SEWER CAPACITY STUDY

SUBJECT: **CITY DOCK NO. 1 MARINE RESEARCH CENTER SEWER CAPACITY STUDY**

TECHNICAL MEMORANDUM NO. 2012-001

SUBJECT: City Dock No. 1 Marine Research Center Sewer
Capacity Study

Figure 3: 2011 Flows with Current Configuration

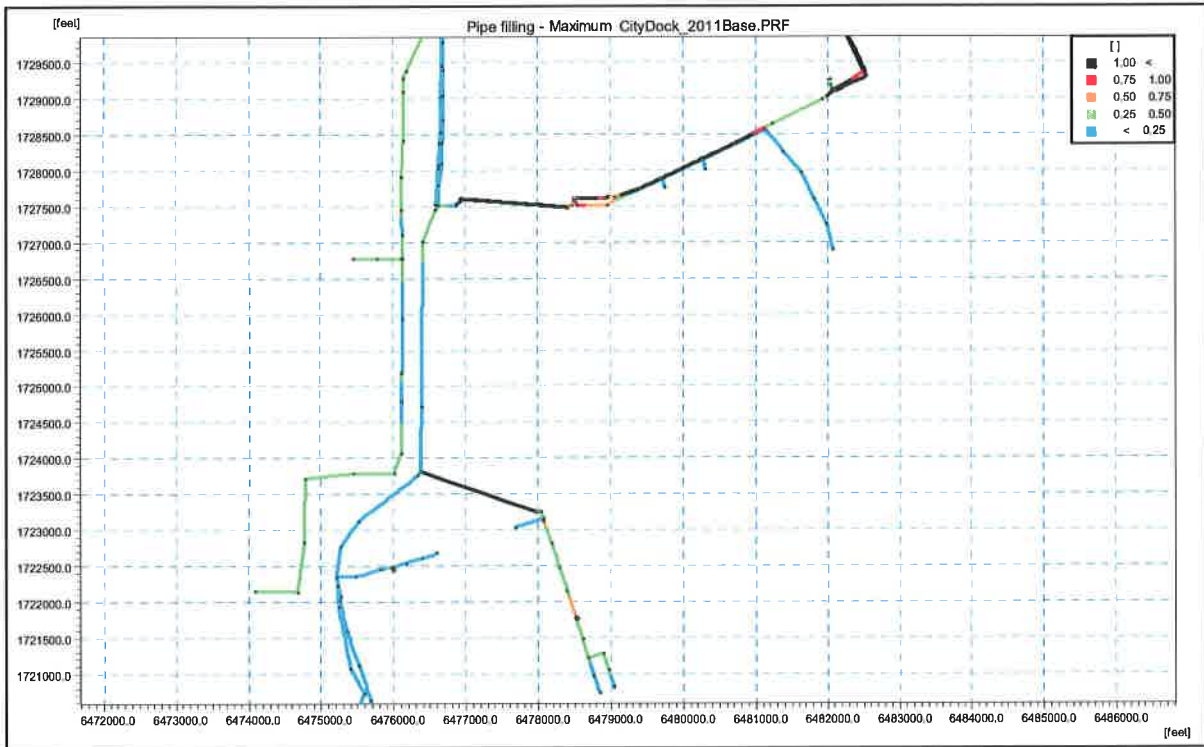
Figure 3 illustrates the current flow conditions within the collection system. The five (5) black/red areas are either siphons or force mains. Since siphons and force mains flow under pressure, the pipe filling (d/D) shows as full.
